EMERGENCY ALERT SERVICE BULLETIN

SUBJECT: ENGINE CONTROLS - Twist grip

Functional check and installation of a protection for microswitches 53Ka and 53Kb and 65K (IDLE / FLIGHT mode)

Corresponds to modification 074699
ATA 76

Figure 1

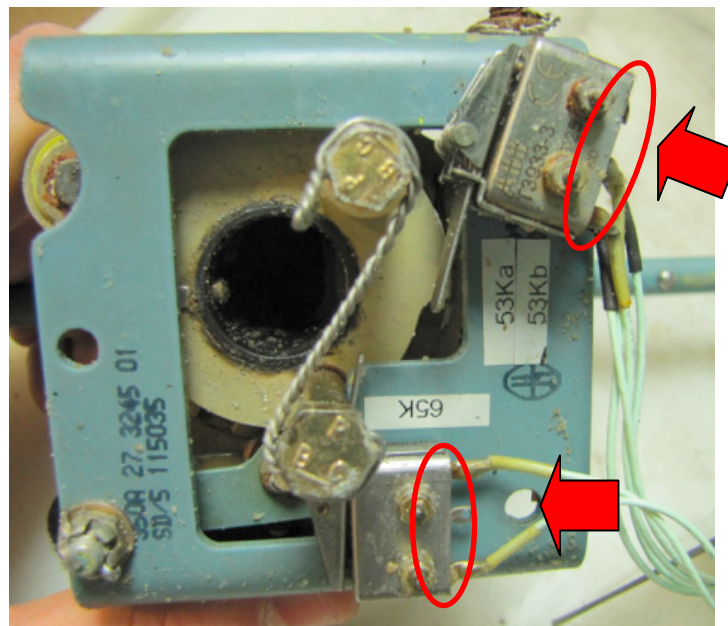
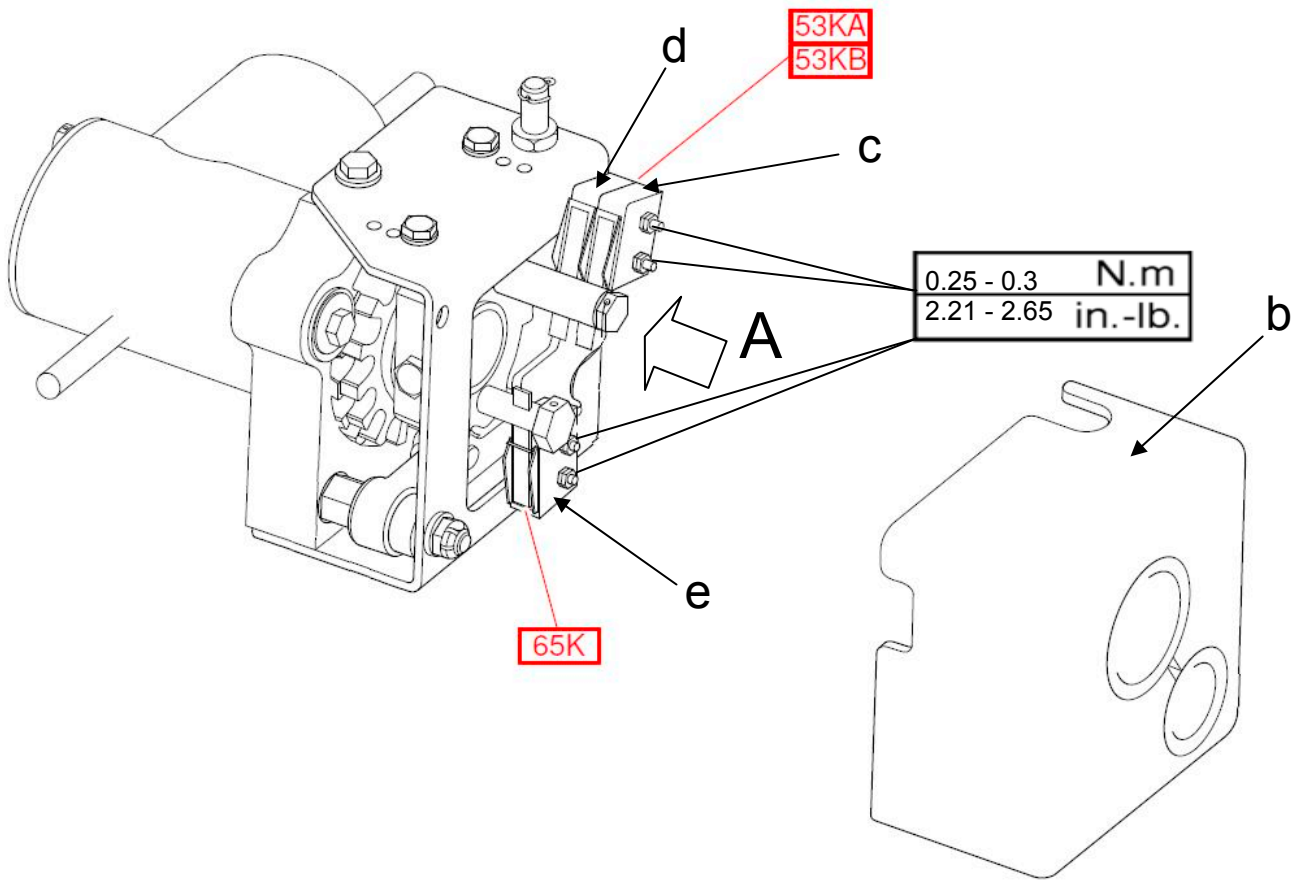
- Inspect the wiring side of microswitches (c), (d) and (e) in order to ensure that there are no marks, residues, corrosion or flaky varnish (DETAIL A - Figure 1).
- If there are marks, residues, corrosion or flaky varnish, comply with paragraph 3.B.2.
- If there are no marks, residues, corrosion or flaky varnish, comply with paragraph 3.B.3.

Figure 2: Electrical continuity test of microswitches 53Ka, 53Kb and 65K

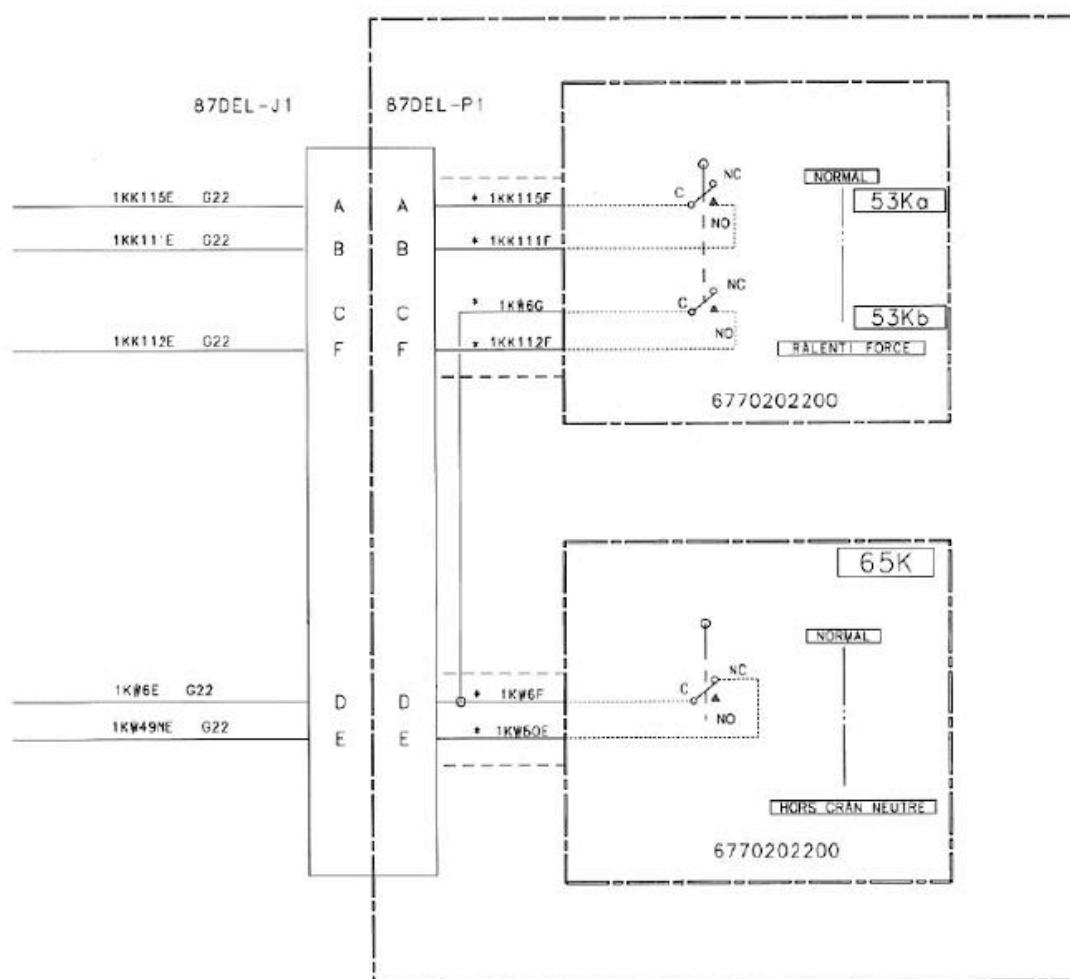
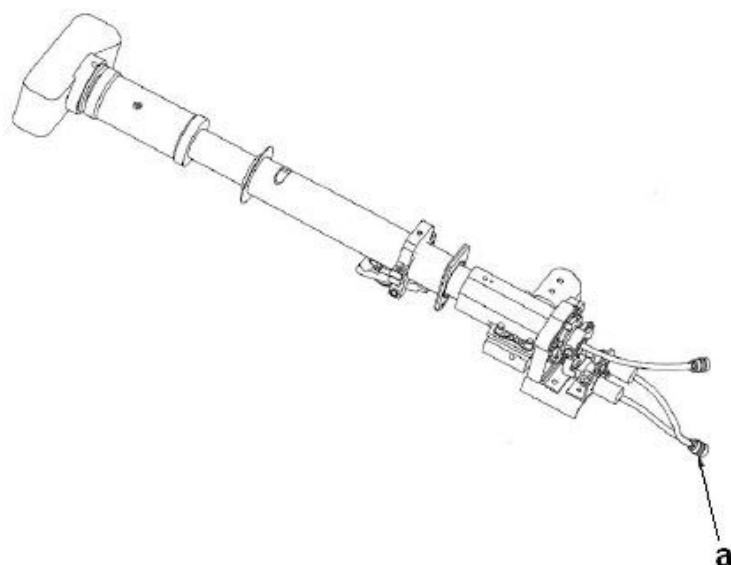
- If not previously disconnected, disconnect electrical connector 87DELTAP1 (a).
- Carry out an electrical insulation test at 50 volts using a megohmmeter (zz) connected between:
 - . the housing of microswitch 53Ka and terminals A and B of connector 87DELTAP1.
 - . the housing of microswitch 53Kb and terminals D and F of connector 87DELTAP1.
 - . the housing of microswitch 65K and terminals D and E of connector 87DELTAP1.

- Connect an ohmmeter (yy) to terminals A and B of connector 87DELTAP1.
- Turn the twist grip from "IDLE" to "FLIGHT" and from "FLIGHT" to "IDLE":
 - . Check on the ohmmeter (yy) that the microswitch closes in the "IDLE" position and opens as soon as the twist grip is turned from the "IDLE" position to the "FLIGHT" position.

Figure 3

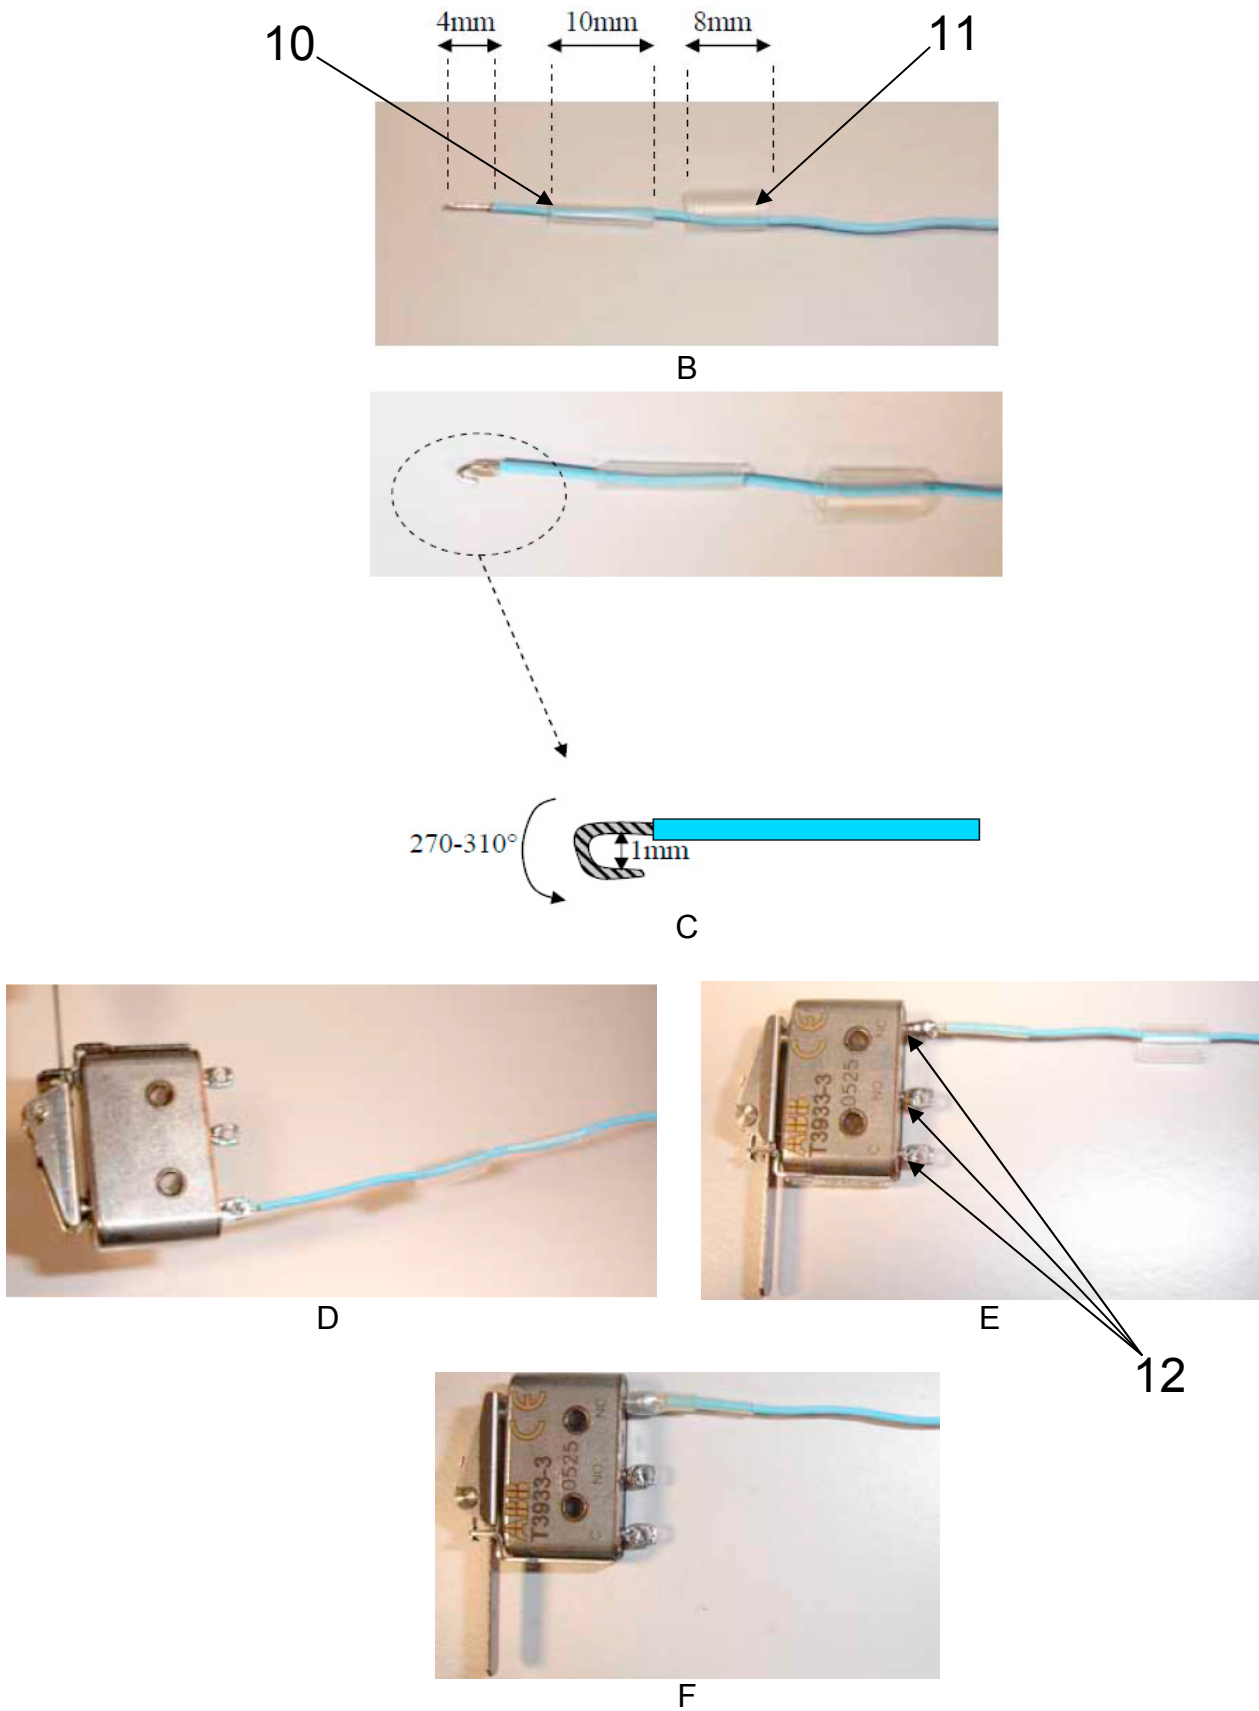
- Strip and tin the wires over a length of 4mm: Detail B.
- Position two pieces of sheath: one 10 mm piece of sheath (10) and one 8mm piece of sheath (11): Detail B.

- Preform the wire strands into a hook shape: Detail C.
- Position the preformed wire strands in the contact hole of the microswitch: Detail D.
- Solder using a soldering iron set to 340°C (tolerance -15°C to +30°C): Detail E.

- Leave to dry until the varnish hardens.
- Position the sheath (10) against the soldered area and shrink fit it: Detail E.
- Position the sheath (11) against the microswitch over sheath (10) and shrink fit it: Detail F.

Figure 4

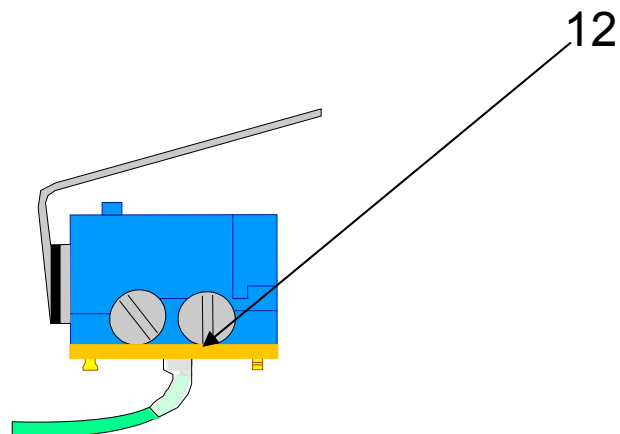
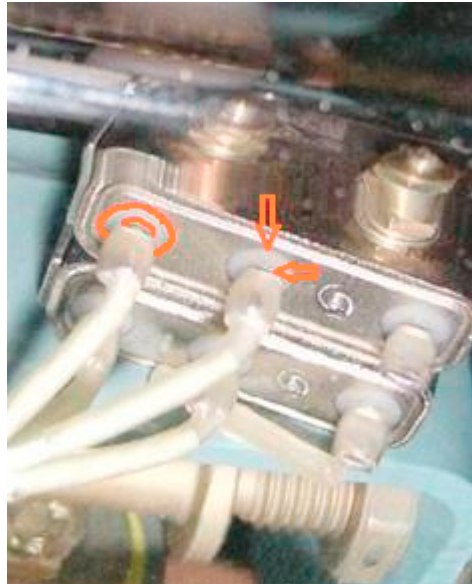
Revision 2 required the application of varnish to the soldered points and unused terminals only. The procedure described below ensures water-tightness of the microswitch by application of varnish to the heel.

- Apply varnish (12) with a brush to (See Diagram - Figure 4):
 - the soldered points of the electrical terminals,
 - the unused terminals,
 - the microswitch "heels" (area where the terminals are located).
- Comply with MTC Work Card 20.04.03.103 without oven-drying the component: Detail E.
- Allow to dry until the varnish hardens.
- Comply with paragraph 3.B.6.
